TENNESSEE VALLEY AUTHORITY

In the Matter of the Application of) Docket Nos. 50-390
Tennessee Valley Authority) 50-391

As a result of discussions between TVA and NRC Region II representatives and of TVA's ongoing review of the Watts Bar unit 1 technical specifications, we have enclosed several additional proposed technical specification changes. Please note that corresponding changes to the Final Safety Analysis Report (FSAR) are also included as appropriate. These changes will be reflected in the next amendment to the FSAR (Amendment 56).

ENCLOSURE

(X)

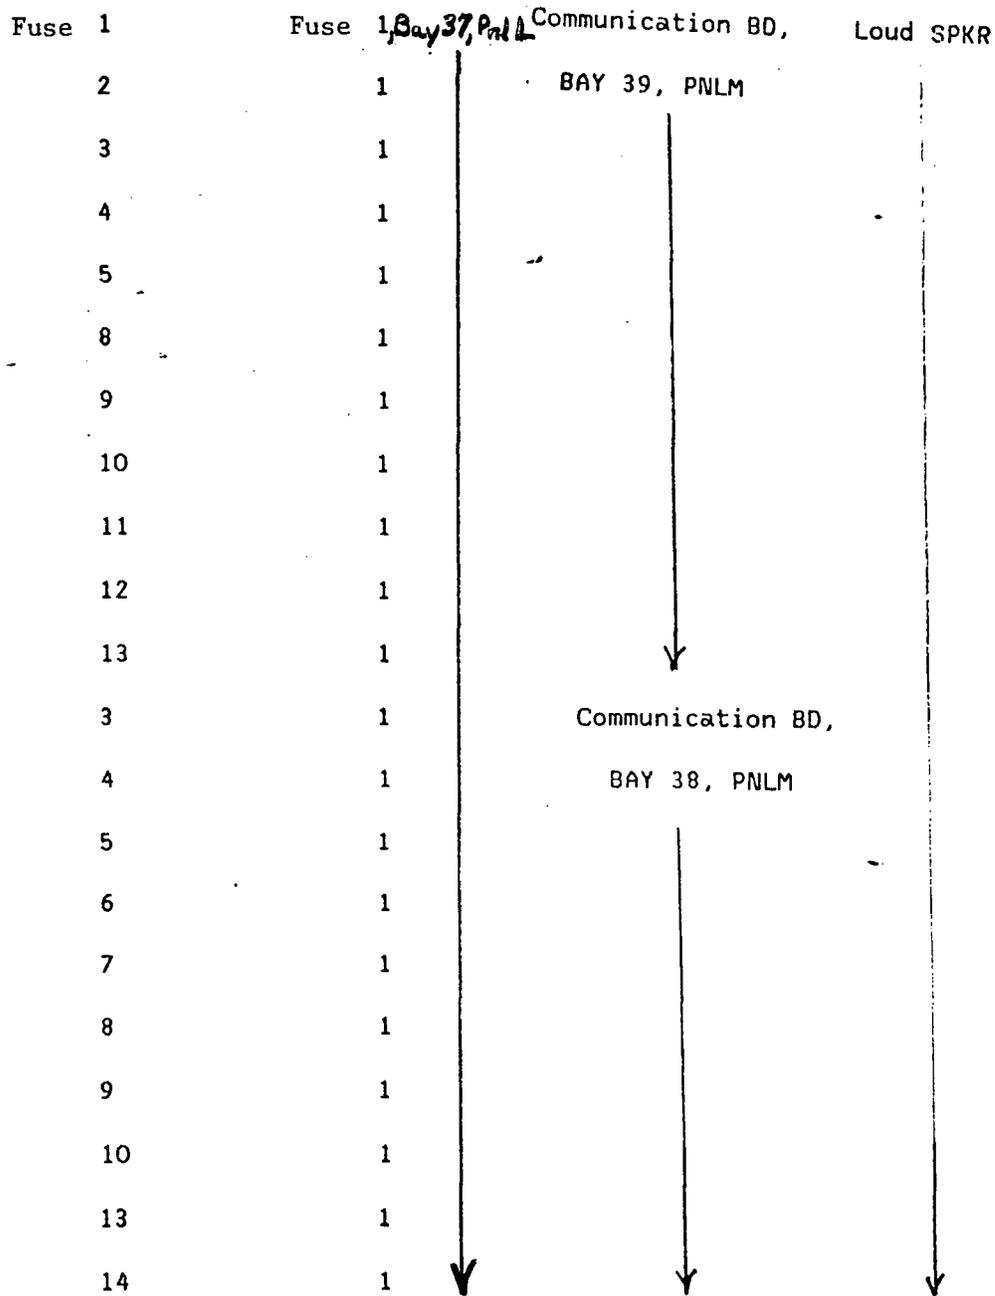
As a result of the review of Table 3.8-1 by the Watts Bar plant quality assurance staff, four changes to TVA's proposed Table 3.8-1 were identified. Attached are marked-up pages showing the following changes:

- (1) Entry on Page 3/4 8-37 which was indicated to be deleted should stay.
- (2) Insert J should have 12A(-) changed to 12A(+) on the primary device number.
- (3) Typographic error corrected on Insert X
- (4) Description of backup devices in Insert SS revised to uniquely identify the fuse.
